Model : GP605

Ref. No. : FF-T01-K1-000014-01

Subject : COUNTERMEASURES FOR A DEVELOPER HAVING A PROBLEM OF CAUSING LIGHT OR COMPLETELY BLANK IMAGE

Fig. 1

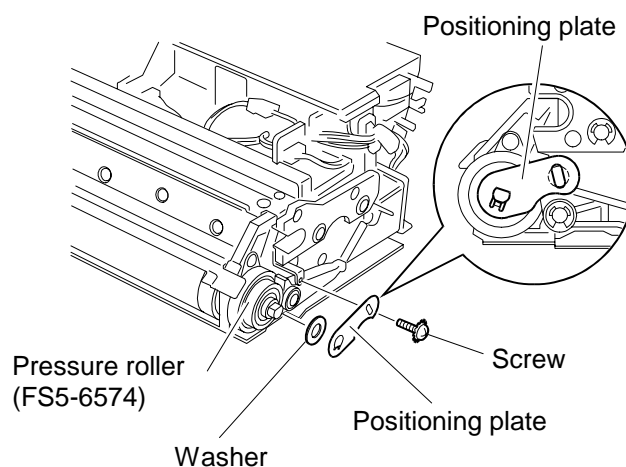
- 1) Remove the screw.
- 2) Remove the electrode positioning plate.
- 3) Remove the washer.
- 4) Clean the pressure roller.

Caution: There can be recurrence of the problem for developers which have had light or completely blank image occurring, and for this reason replace the pressure roller.

Fig. 2

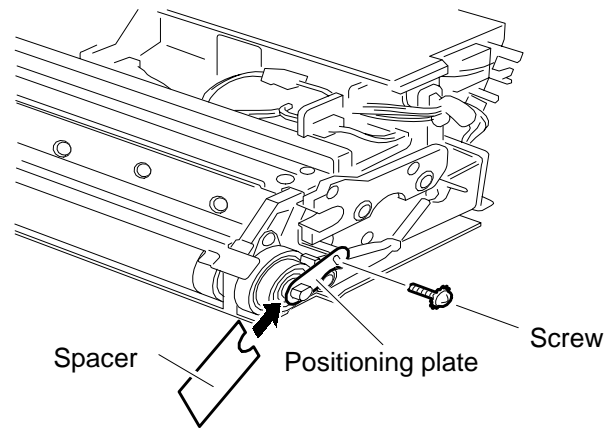
- 5) Insert the spacer (for example, OHP sheet of about 0.2mm thickness) and place the electrode positioning plate.
- 6) Tighten the screw.
 - * Since there is a magnet in the developer sleeve roller, tighten the screw at the natural position without going against the effect of the magnet.

Fig. 3

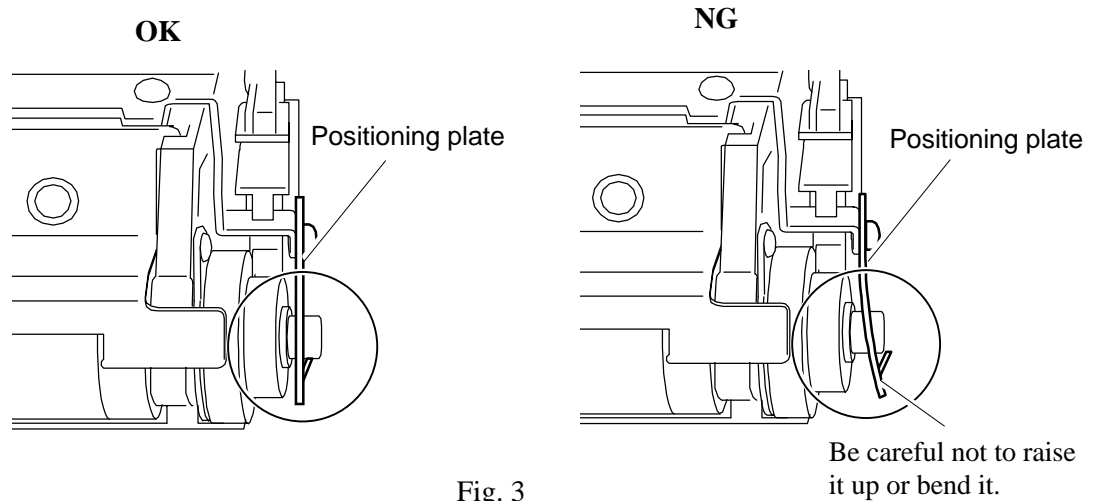
Caution: In attaching the electrode positioning plate, exercise caution not to raise it up or bend it.
